SUBMISSIONS REPORT

SSDA-8865 Mod 1
St Anthony of Padua Catholic
College

SYDNEY CATHOLIC SCHOOLS

1 December 2021

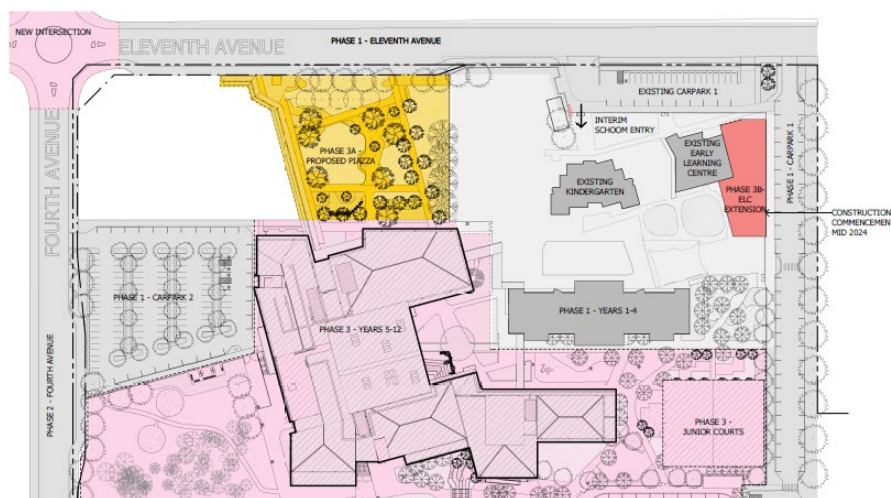
Action	Description
Continued engagement	<u>Liverpool Council</u> SCS met with Council on 15 November 2021 to discuss the timing for the delivery of the roadworks surrounding the site. This included discussion of the recent completion of roadworks to Eleventh Avenue and the land acquisition process for the roundabouts. SCS and Council meet regularly and this engagement will be ongoing.
Refinement of Construction Phases	SCS has reviewed the elements within Construction Phase 3. Sub phases within Construction Phase 3 have been created, these are: - Construction Phase 3 – Main School building - Construction Phase 3A – The Piazza to Eleventh Avenue - Construction Phase 3B – Early Learning Centre These sub phases reflect the need to obtain a separate construction certificate and occupation certificate for the main school building. When the main school building is operational the demountable classrooms adjacent to Eleventh Avenue will be able to be decommissioned and removed from the site. This area will then be cleared for the construction of the Piazza (Construction Phase 3A) and then the Early Learning Centre (Construction Phase 3B). The sub phases are critical to enable the issue of the occupation certificate for the main school building and the operation of the school. The proposed sub phases have been shown on the amended architectural drawings at Appendix A. Prior to the construction of the Piazza, an interim entrance to the school will be available via Carpark 1. This is shown in the excerpt from the amended construction phasing plans below.
